# E-3 AWACS CORROSION PREVENTION ADVISORY BOARD (CPAB)

12 JULY 1990  
TINKER AFB, OK

**E-3 CORROSION PREVENTION ADVISORY BOARD MINUTES  
12 JULY 1990**

Figure 6-9. Outboard Wing Assembly

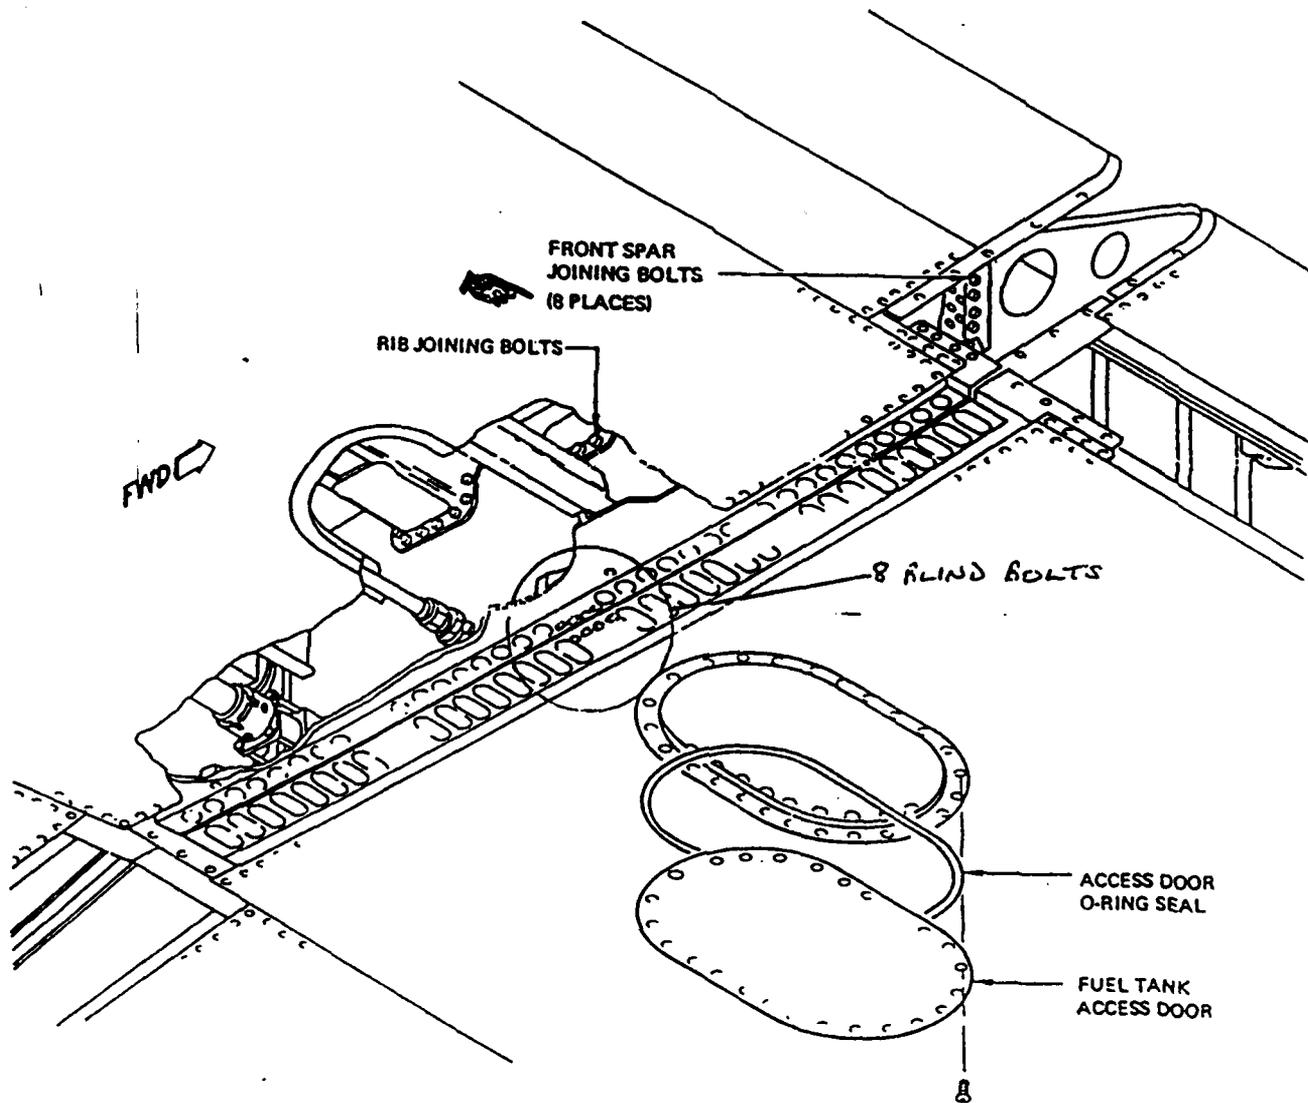
MMKRA will included inspection of the lower surface in T.O. -6 and FY91 ACI. MMKRA will take action to investigate the addition of of drain holes.

Figure 9-1. Nose Gear Oleo Assembly (Sheet 2 of 3)

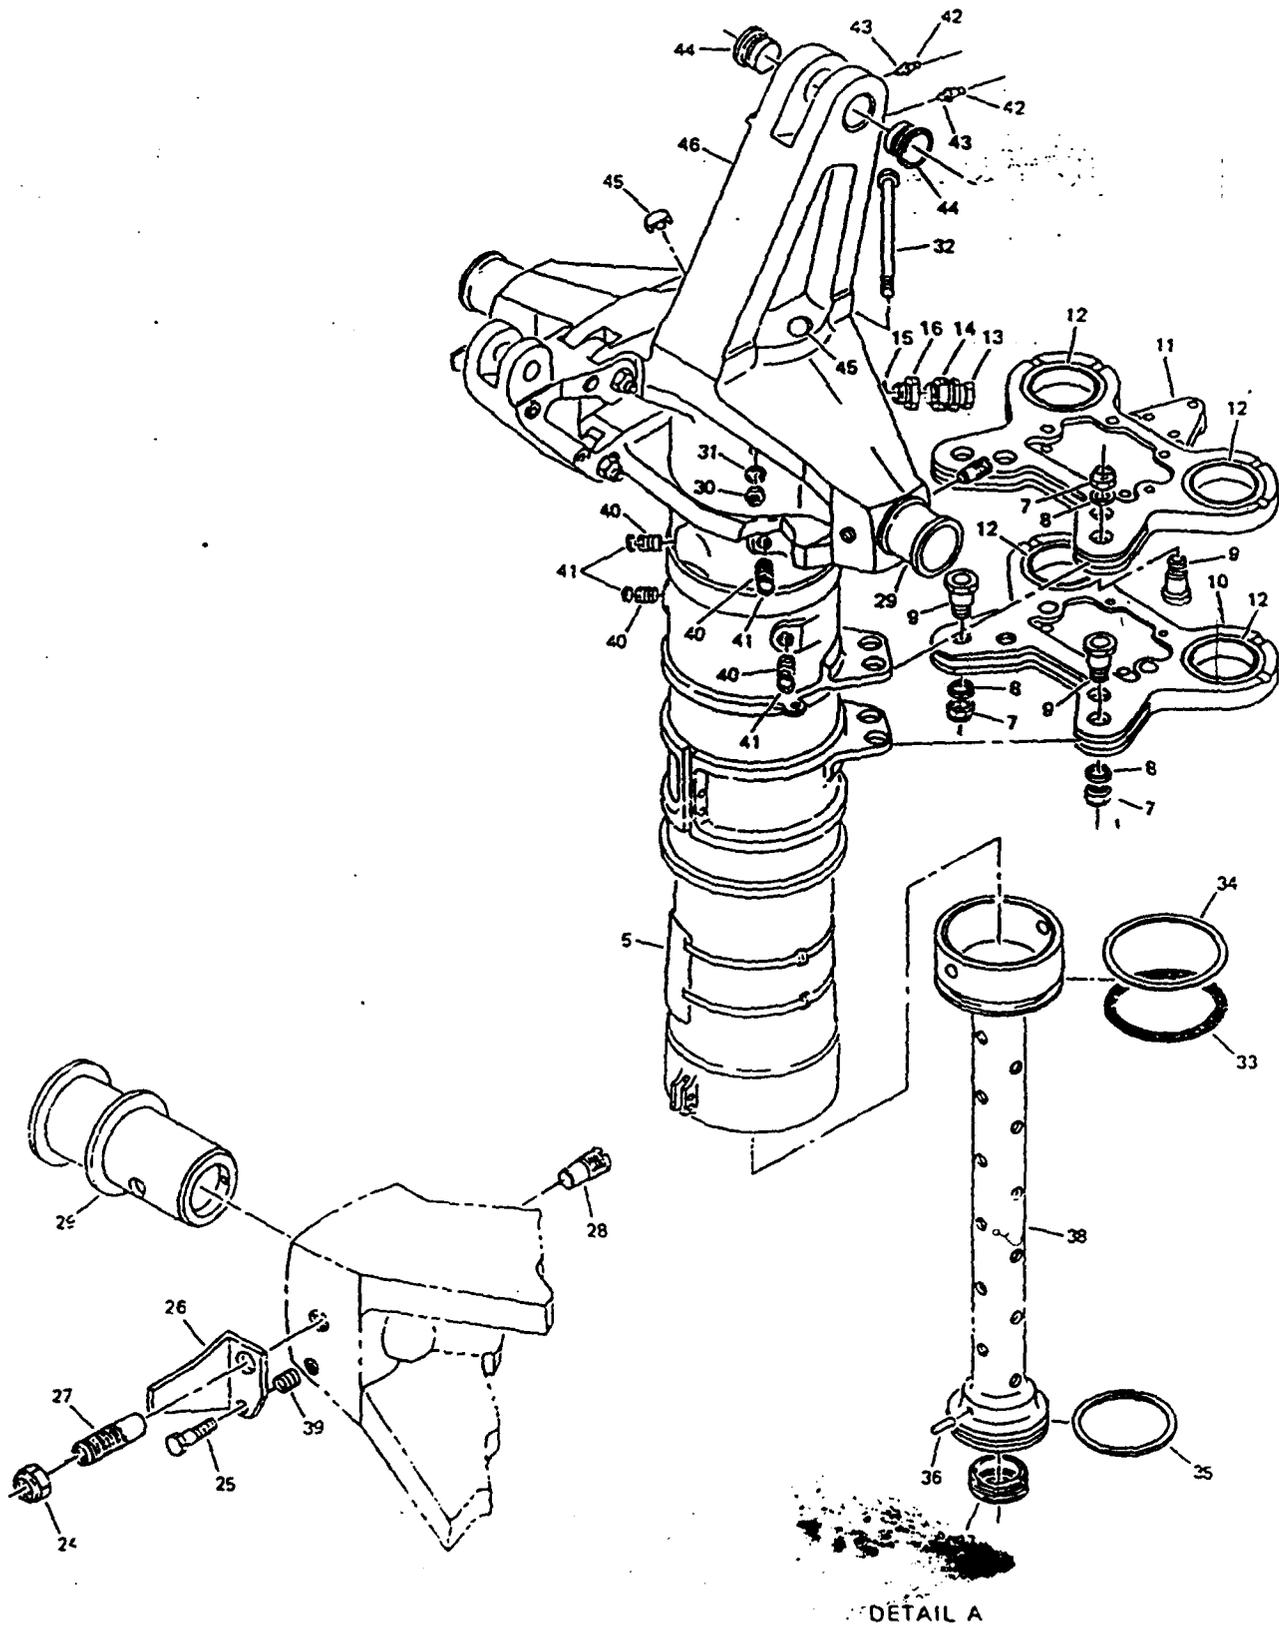
E-3	CORROSION PREVENTION ADVISORY BOARD		ACTION ITEM #: 89-14
O R I G I N A L T O R	<b>SUBJECT:</b> Nose Landing Gear Trunnion and Bearing Assembly	<b>BACKGROUND DATA:</b>  <b>PART NUMBER:</b>  <b>NSN:</b> <b>DRAWING(S):</b>	
	<b>NAME:</b> HFw Franz-Josef Deckers <b>ORGANIZATION:</b> NAEWF E-3 Comp. <b>TELEPHONE:</b> 01-49-2451-63-6215 <b>DATE SUBMITTED:</b> 16 NOV 1989	<b>TO(S):</b> 1E-3A-4-32-1 <b>FIGURE:</b> 32-03-23 <b>INDEX:</b> 18/19 <b>WORK UNIT CODE:</b>	
	<b>PROBLEM:</b> During lubrication of NLG trunnion, it was noted that no grease could be applied. After removal of lower NLG trunnion fitting caps and bearing halves, it was discovered that the grease channel of the lower bearing halves were clogged. Trunnions had slight surface corrosion.		
	<b>RECOMMENDED ACTION:</b> 1) Add to phase every 1380 hours to remove lower trunnion fitting caps and inspect bearing and trunnion, 2) Accomplish lubrication more frequently, and 3) Change grease from present MIL-C-21165 to MIL-G-23827 for all grease locations on landing gear. (USE CONTINUATION SHEET IF NECESSARY)

C P A B  A C T I O N	<b>STATUS:</b> Nov 1989: Based on findings, E-3A Component has initiated a one time inspection (OTI).  16 Nov 1989: OC-ALC/MMKRA will investigate problem and make Tech Order changes as necessary.  12 March 1990: A cost estimate of an EST is being developed by Boeing to investigate applying a dry film lubricant to the surfaces of the bearing. If this is feasible, existing grease holes will be plugged and frequent lubrication will no longer be required.  July 1990: MMKRA will pursue testing locally before submitting an EST to Boeing.		
	<b>ACTION OPR(S):</b> OC-ALC/MMKRA	<b>POINT(S) OF CONTACT:</b> Jon Kimmel	<b>EST. COMPLETION DATE:</b>
<b>STATUS:</b> OPEN <b>DATE CLOSED:</b> <b>FINAL DISPOSITION:</b>
